26257B DETENT COVER ASSEMBLY

INSTRUCTIONS FOR REPLACEMENT OF LOG SPLITTER VALVE DETENT COVER ASSEMBLY

36561B DETENT COVER ASSEMBLY

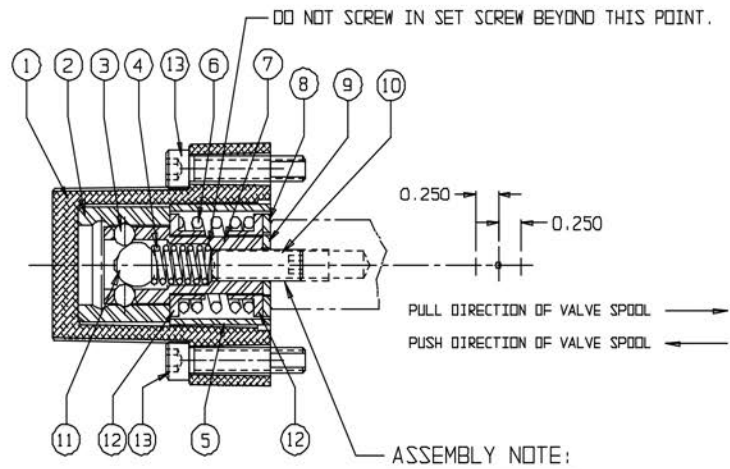
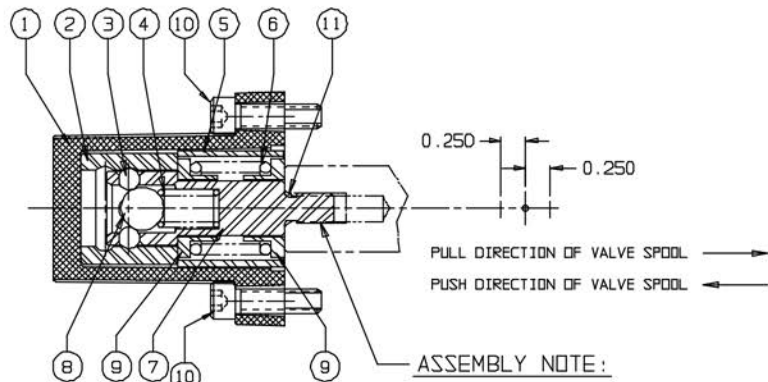
****NOTE**** these instructions apply to replacement of the detent cover assembly with 36561B shown below. The 36561B is the latest design. Your valve may have an older design as shown above. The respective assemblies are interchangeable on the valve; however, **DO NOT** interchange parts between the old and new detent assemblies. **Doing so may cause the valve to malfunction, possibly creating a safety hazard.**
